NHTSA Concerns with Proposed Amendment 3 to GTR 9

ECE/TRANS/WP.29/2021/53

For the 69th GRSP

2010 Acura MDX

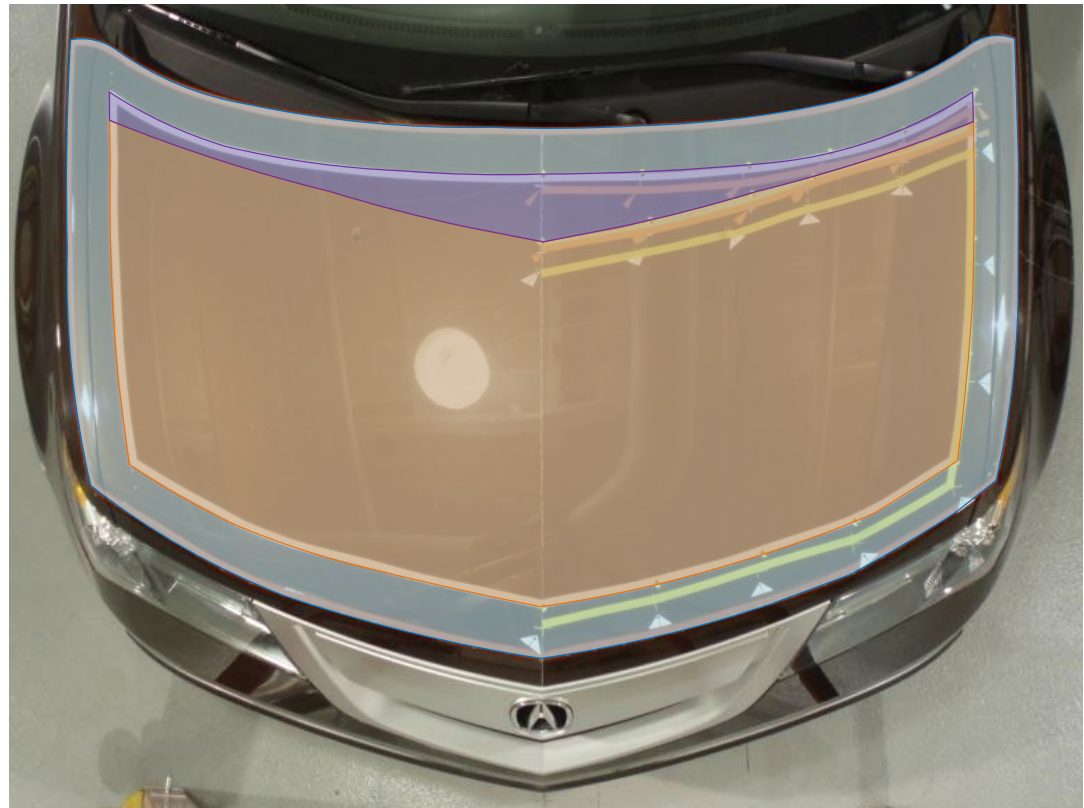
To evaluate how the US interpretation of the existing language and the proposed amendment compare, NHTSA looked at different vehicles from its original evaluation of the GTR.

| | NHTSA | Amendment |
| Child Test | 84% | 67% |
| Adult Test | 16% | 6% |
| No Test | 27% | 27% |
| HIC1000 | 67% | 49% |
| HIC1700 | 7% | 24% |

2011 Hyundai Tucson

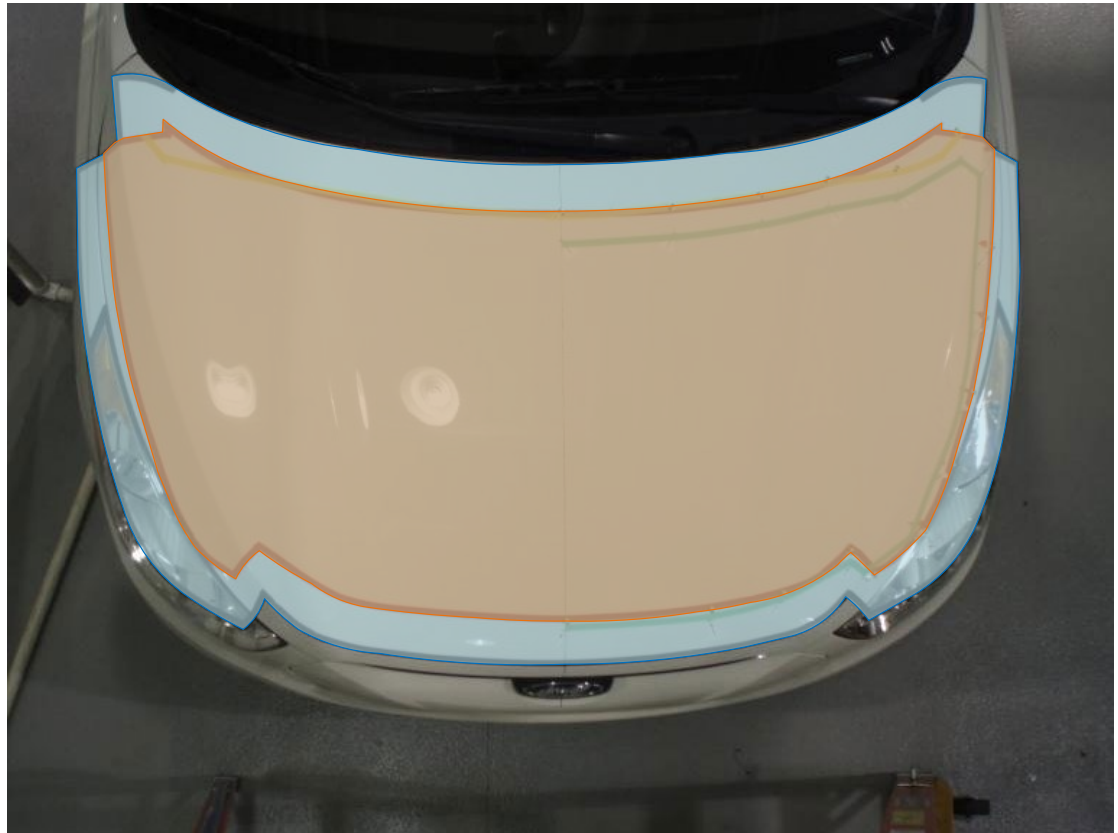
| | NHTSA | Amendment |
| Child Test | 100% | 76% |
| Adult Test | 0% | 0% |
| No Test | 24% | 24 |
| HIC1000 | 67% | 51 |
| HIC1700 | 10% | 25 |

2011 Jeep Charokee

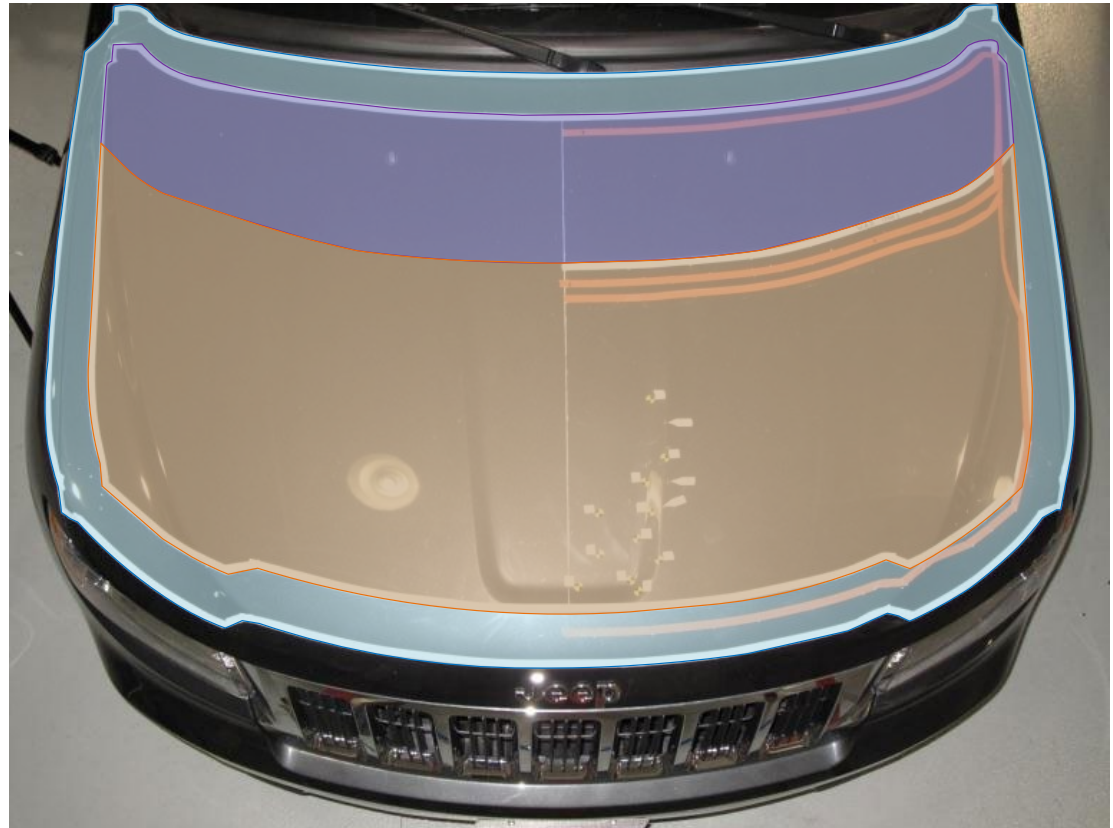
| | NHTSA | Amendment |
| Child Test | 71% | 57% |
| Adult Test | 29% | 22% |
| No Test | 21% | 21% |
| HIC1000 | 67% | 52% |
| HIC1700 | 12% | 26% |

2010 Kia Forte

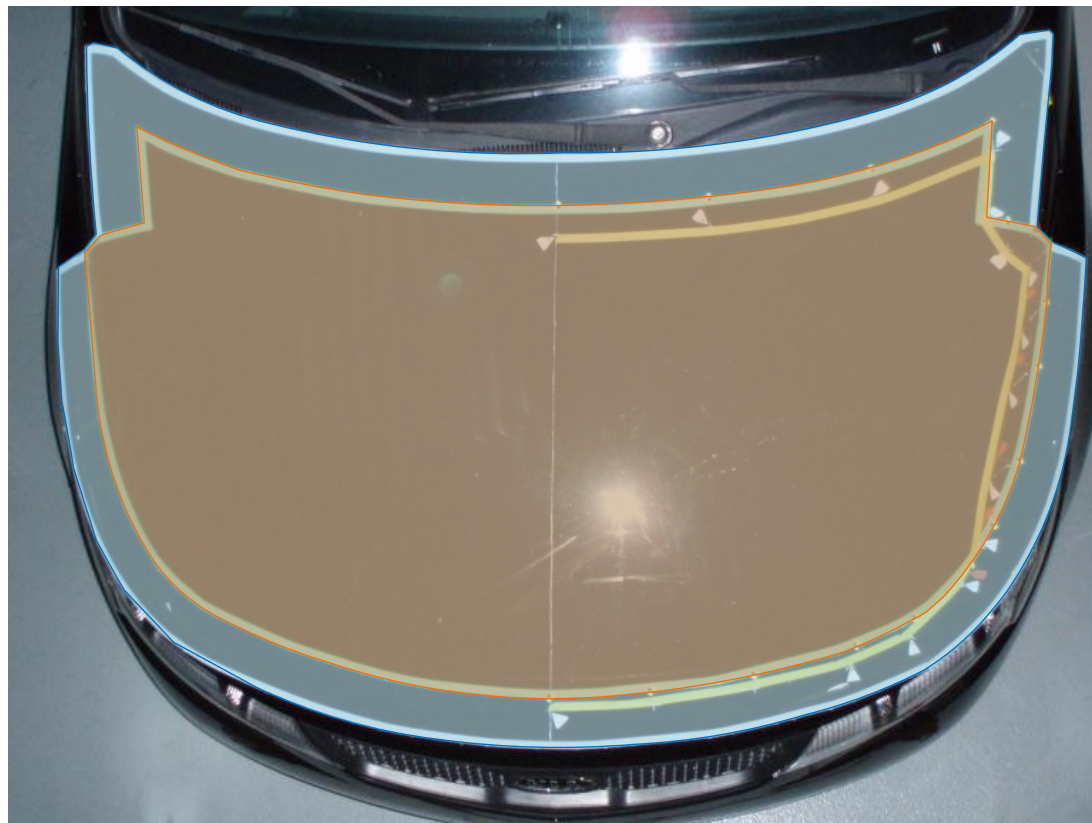
| | NHTSA | Amendment |
| Child Test | 100% | 76% |
| Adult Test | 0% | 0% |
| No Test | 24% | 24% |
| HIC1000 | 67% | 51% |
| HIC1700 | 9% | 25% |
